Our ref: 70014753-004

November 27, 2019

**Subject: The Water House 2019/5226/P – Technical Review of Fencing Proposals**

DRAWING No: <b>7453-004-SK-001</b>	REV: <b>P01</b>
---------------------------------------	--------------------

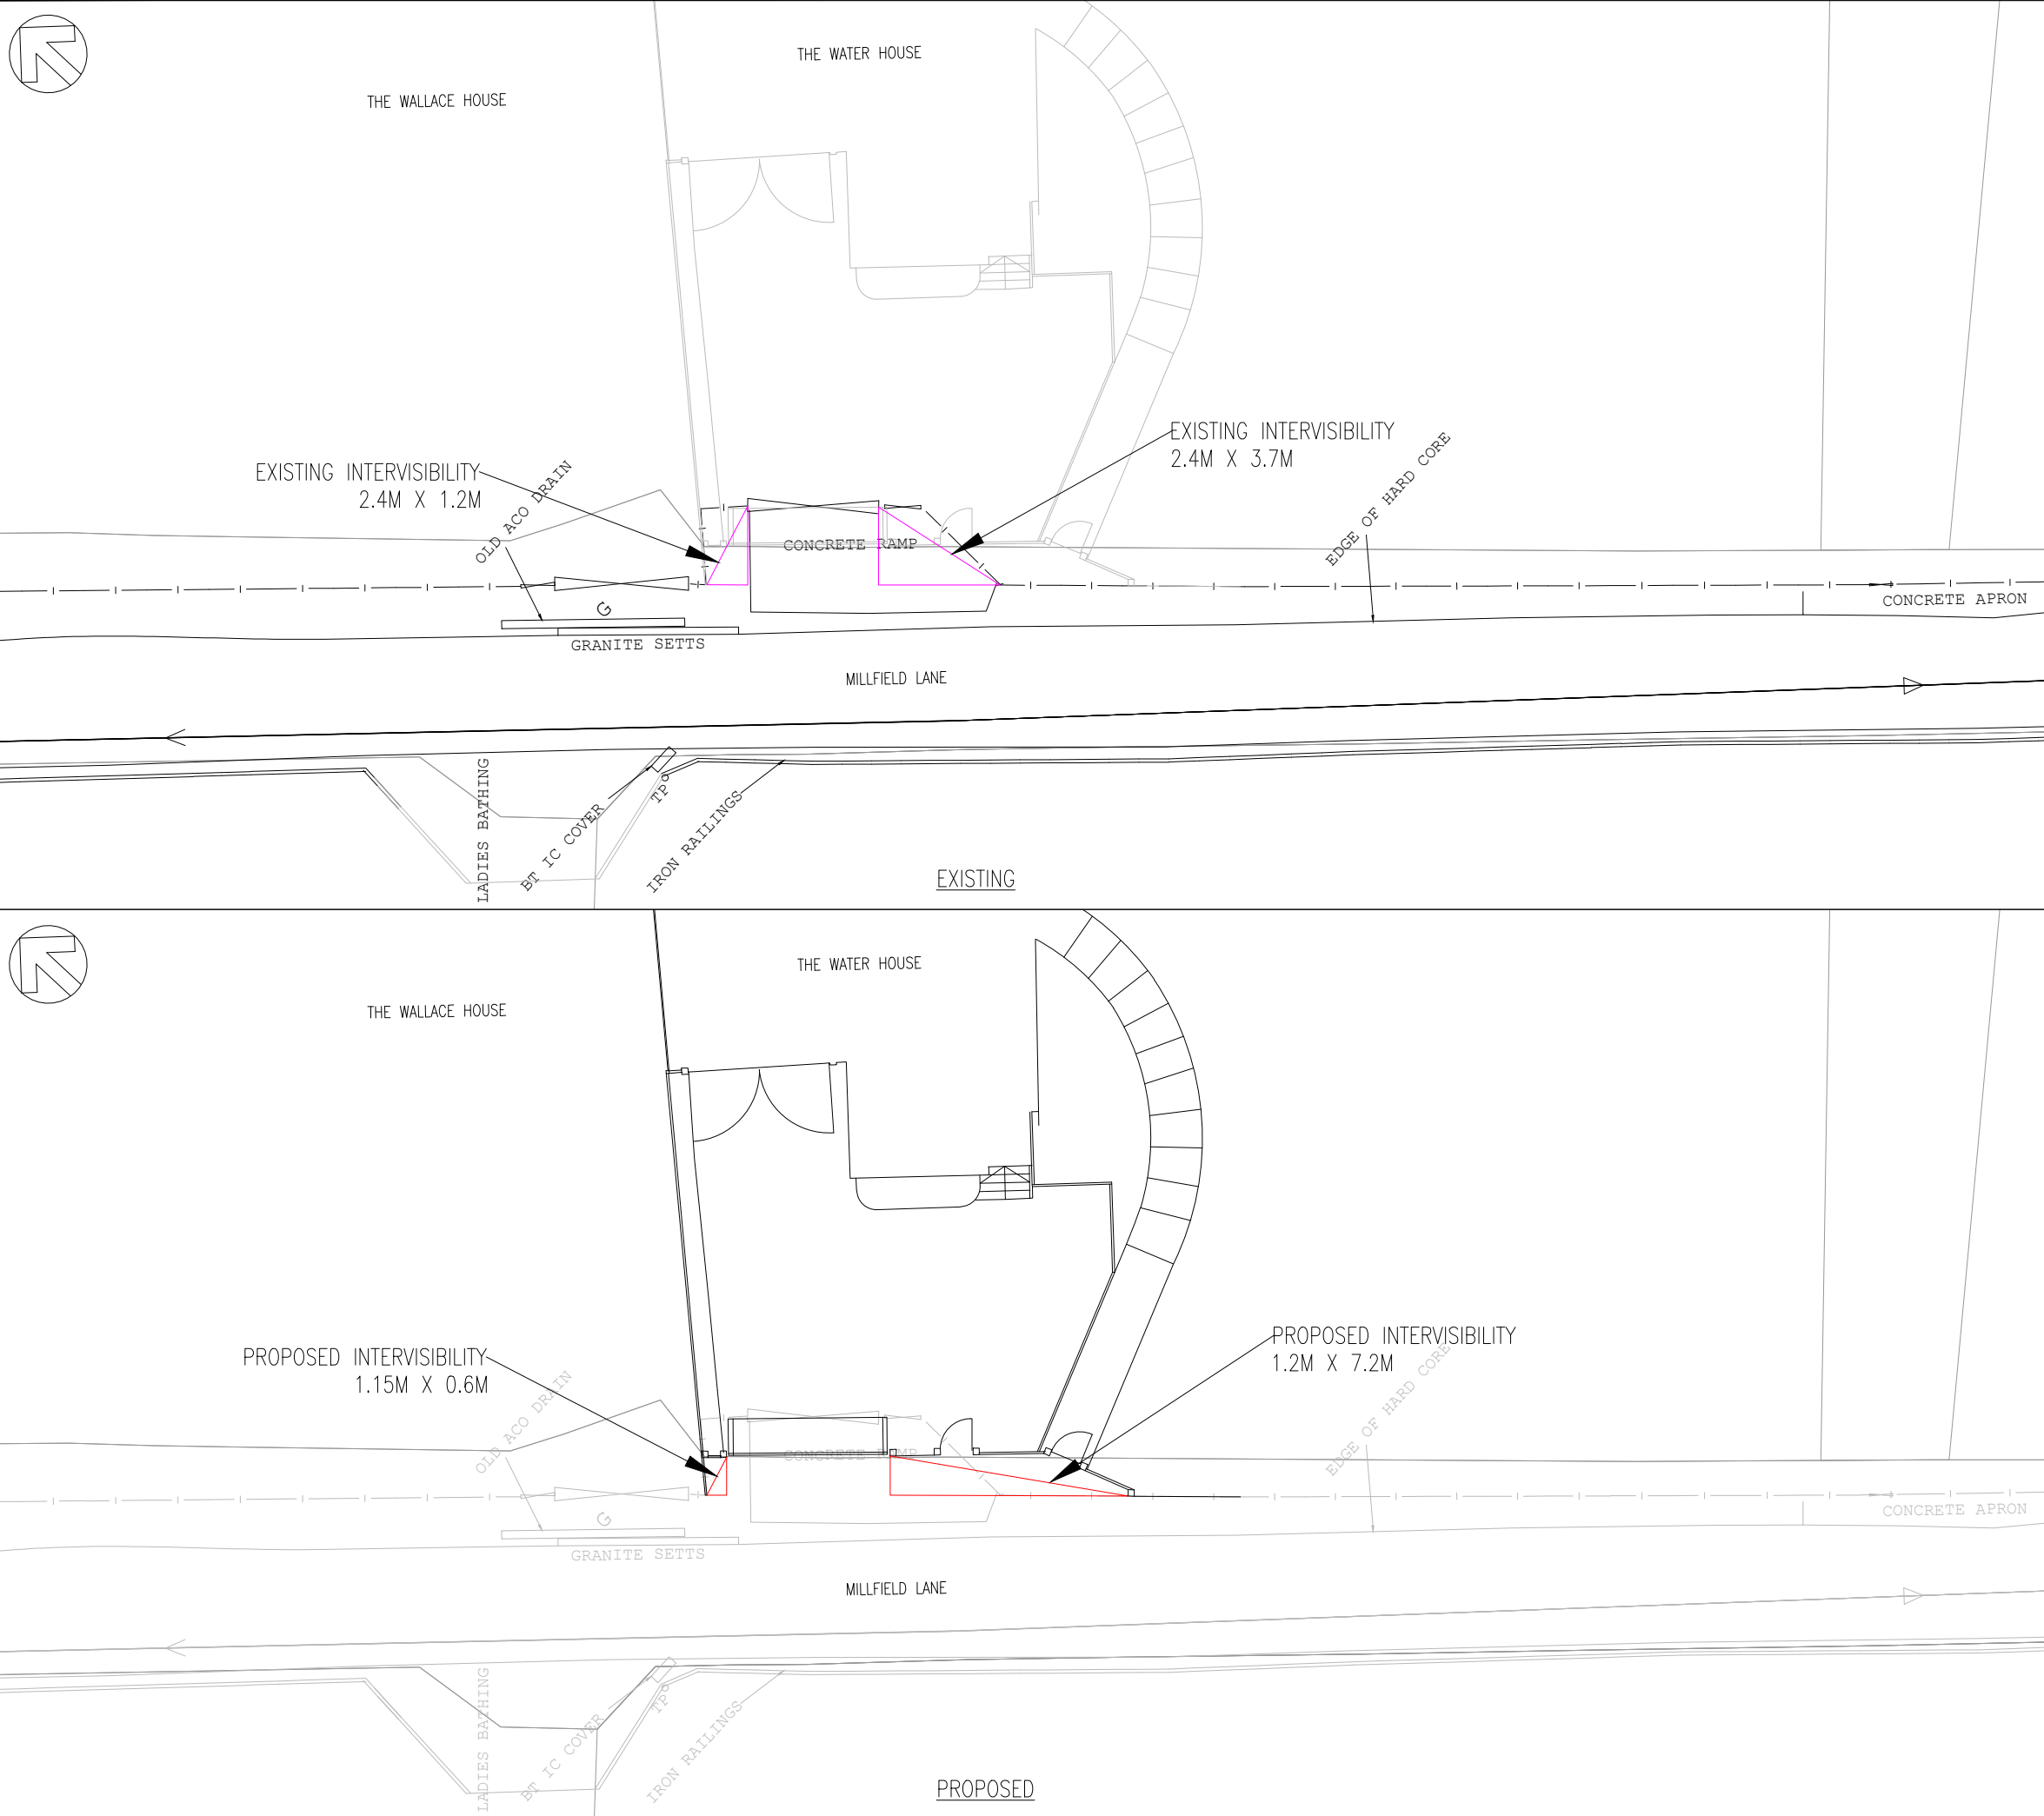
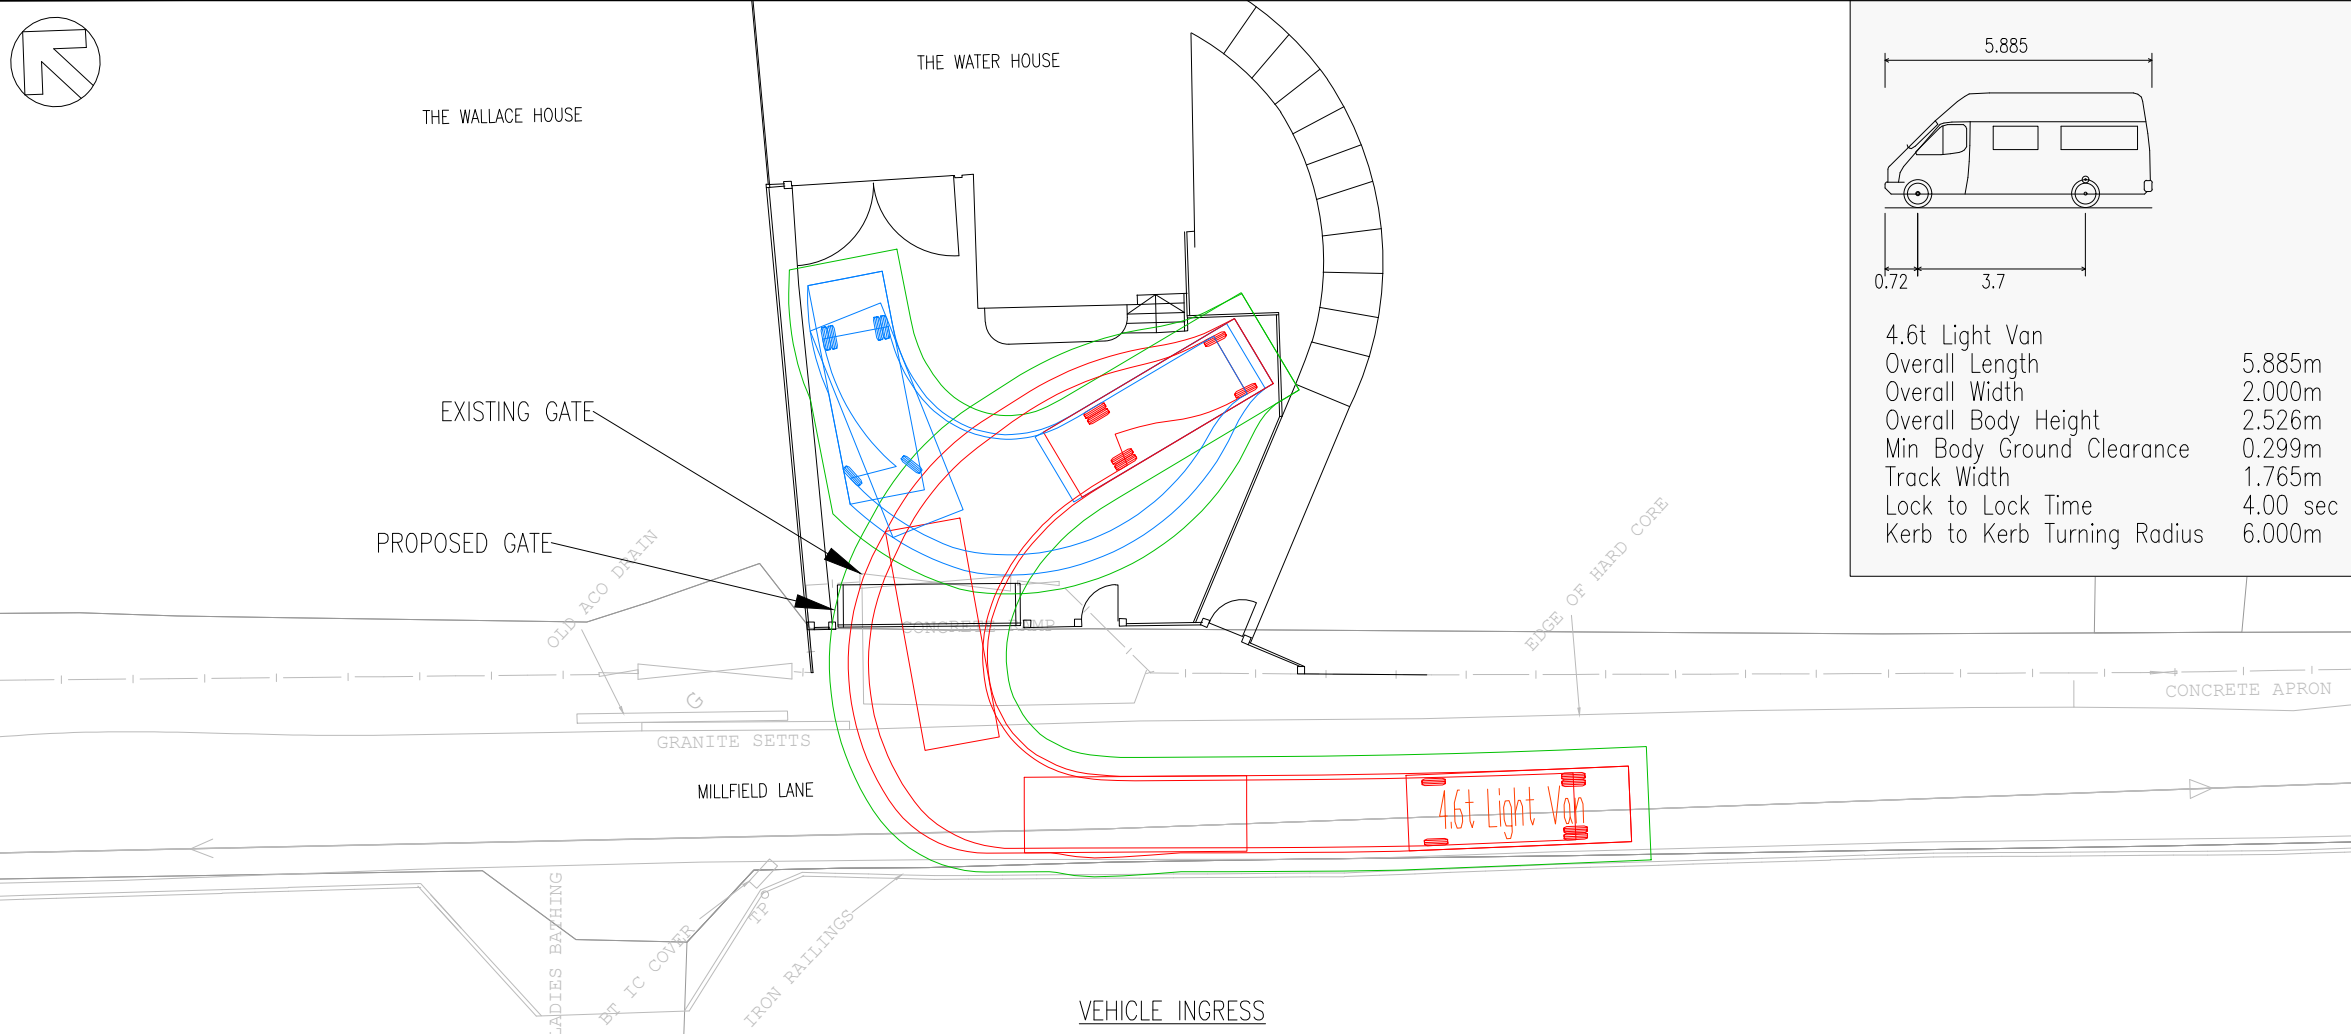
As part of our review we have assessed the pedestrian inter-visibility splay (i.e. the visibility between pedestrians and vehicles at a vehicular crossover or access) for the existing and proposed layout of The Water House as shown on drawing 7543-004-SK-001.

The proposed amendments to the gate reduce the pedestrian inter-visibility splay on the western side from 2.4 x 1.2m to 1.15 x 0.6m.

We note that the available guidance documentation from Camden does not stipulate a minimum inter-visibility splay therefore we have deferred to guidance produced by other local councils such as Kent County Council and Surrey County Council. Under such guidance a typical, recommended and best practice, inter-visibility splay for a vehicular entrance crossing a footway or other pedestrian route would be 2 x 2m, and therefore in this instance the existing inter-visibility splay would be considered substandard.

The proposals therefore further reduce the inter-visibility and provide a much more limited distance for pedestrians approaching to be able to see a vehicle exiting the property, or for a vehicle exiting the property to see and therefore avoid a conflict with a passing pedestrian.

The proposals in their current state present an increased risk to pedestrians walking west-east along Millfield Lane and we would recommend the applicant's current proposals are revisited to address and provide an equivalent, or where possible, improved inter-visibility to the existing configuration in accordance with best practice.

DRAWING No: **7453-004-ATR-001**      REV: **P02**

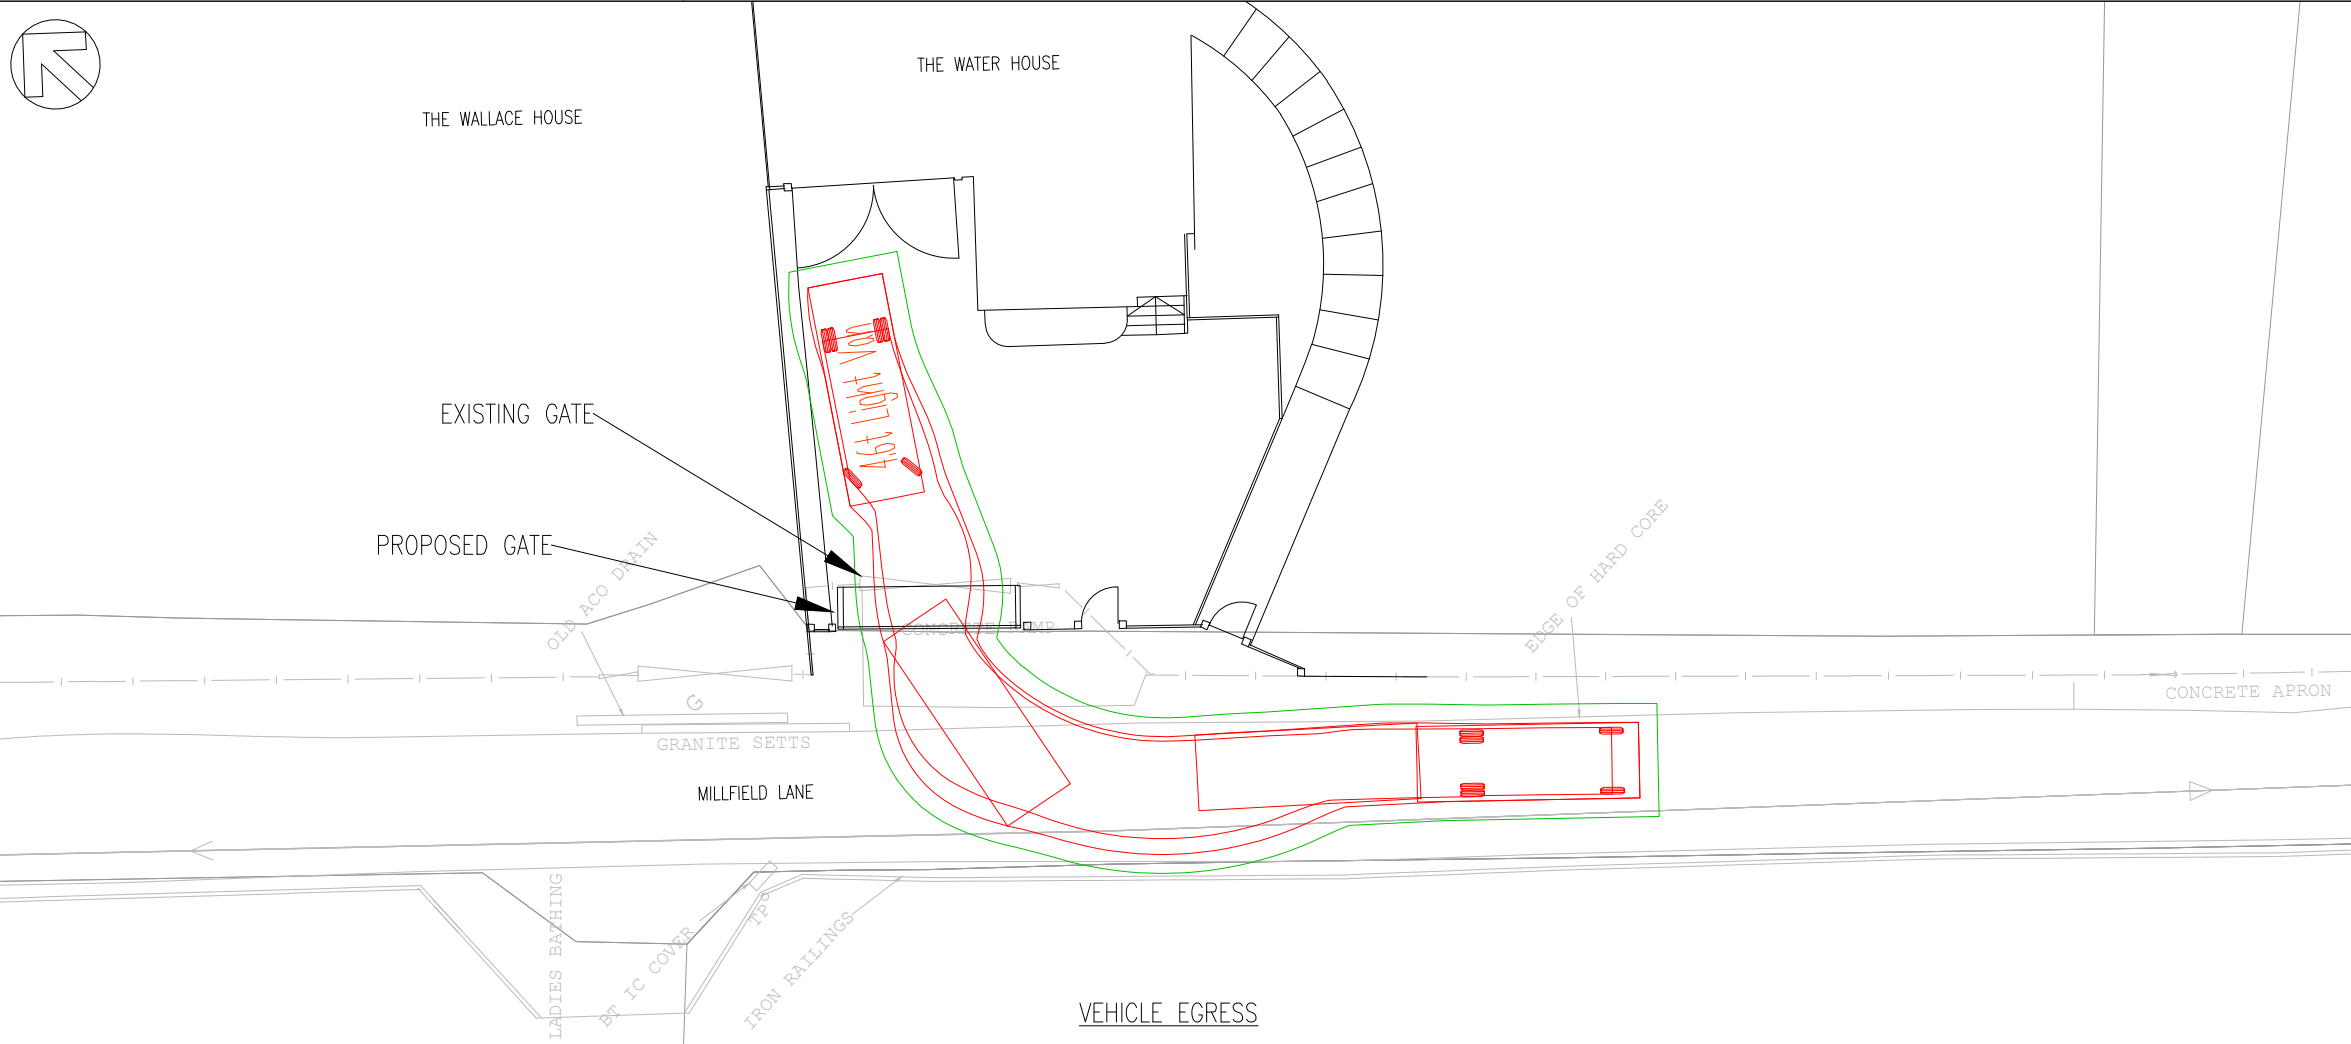
We have also undertaken swept path analysis (ref 7543-004-ATR-001) to review the proposed movement for a light van to enter the property, turn around and exit the property in a forward motion as shown on TPP Consulting drawing '2019-3669-TR\_03A'. Based on our analysis it appears that this movement is possible, however note that the turning area inside the gate would need to remain clear at all times to allow it to be undertaken. If there were to be any obstruction in this area it appears that vehicles would be required to reverse onto Millfield Lane, which given the substandard visibility splays and non-standard nature of Millfield Lane, would present a significant safety risk.
